2006 International Residential Code and Commentary Errata

1st and 2nd PRINTING (December 7, 2018)

Figure R406.2

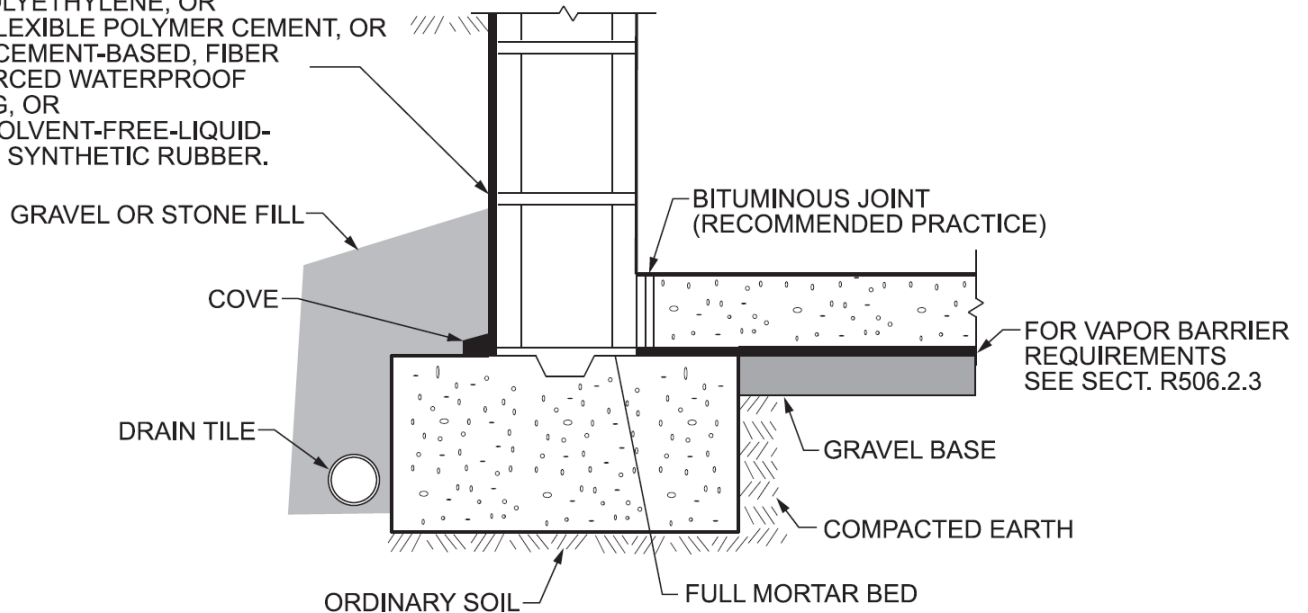
- WATERPROOFING MEMBRANE
1. TWO-PLY HOT MOPPED FELT, OR
 2. 6-MIL PVC, OR
 3. 55-POUND ROLL ROOFING, OR
 4. 40-MIL POLYMER-MODIFIED ASPHALT, OR
 5. 6-MIL POLYETHYLENE, OR
 6. 60 MIL FLEXIBLE POLYMER CEMENT, OR
 7. 1/8 INCH CEMENT-BASED, FIBER REINFORCED WATERPROOF COATING, OR
 8. 60 MIL SOLVENT-FREE-LIQUID-APPLIED SYNTHETIC RUBBER.
